TO: CITY MANAGER

FROM: DIRECTOR PLANNING AND BUILDING

SUBJECT: FOREST LAWN CEMETERY
MASTER PLAN SUBMISSION

PURPOSE: To provide Council with information and comments on a Master Plan submitted for Forest Lawn Cemetery.

SKETCH # 2

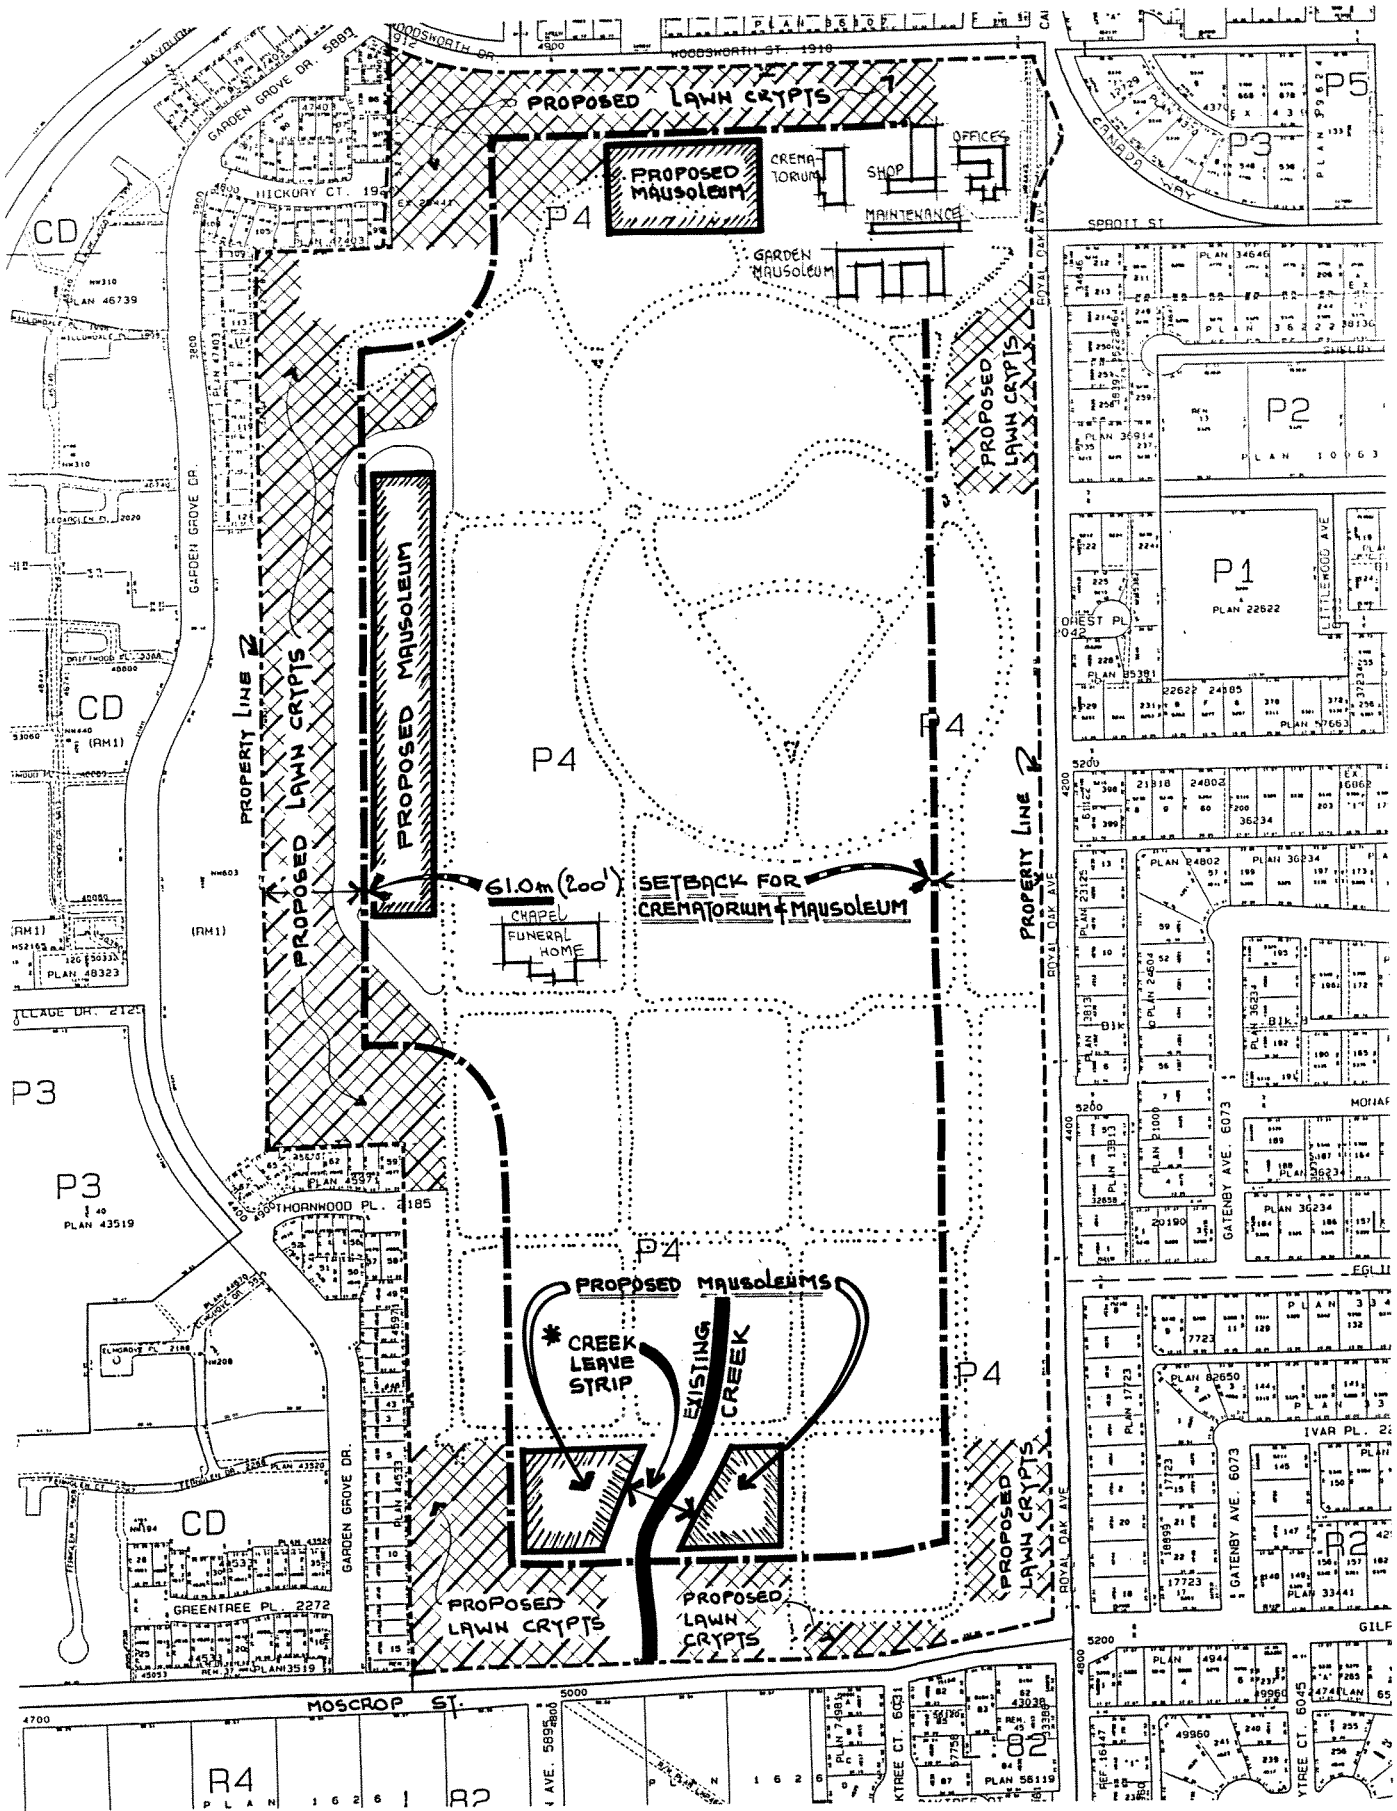
- 2.5 With respect to the development of in-ground burial sites to within 2 feet of the property lines, staff have expressed concern that this represents loss of an environmental amenity. The elimination of existing forested areas around 100m (328 ft.) in width along the western property line represents a significant loss of natural forested habitat which may provide a vegetated connection or wildlife corridor particularly for birds to the western forested area of Deer Lake Park. This forested area, which is comprised primarily of second growth alder, currently provides a buffer between the cemetery and the residential area of Greentree Village. Staff have suggested that a north/south vegetated corridor be preserved with potential augmentation of the planting in the buffer to reduce the risk of blow down and to enhance diversity. It was originally suggested that a 60 foot wide buffer area be protected. Forest Lawn's landscape architect has indicated that due to the species and condition of the trees within this forested area, a much greater width of corridor would need to be preserved in order to protect the integrity of the forested area and prevent trees being blown over. Burnaby's Arborist has assessed this forested area and concurs that a 60 foot wide buffer area would be inadequate to protect the inner forest. It is recommended that at least 50% of the existing width be protected and that other protective measures be taken.

- 2.6 While staff recognize the utility of developing cemetery lands for lawn crypts for in-ground burial in light of the regulations restricting mausoleums and the demand that exists for in-ground burial, the loss of significant forested area is also of great concern in terms of it being an environmental amenity and providing buffering/screening for abutting residents. It does appear, however, that Forest Lawn's Master Plan proposal is not at variance with the present regulations in the Burnaby Zoning Bylaw and that there are no additional requirements of the Ministry of Environment, Lands and Parks or the Department of Fisheries and Oceans which would prohibit the removal of the forested area discussed in Section 2.5.
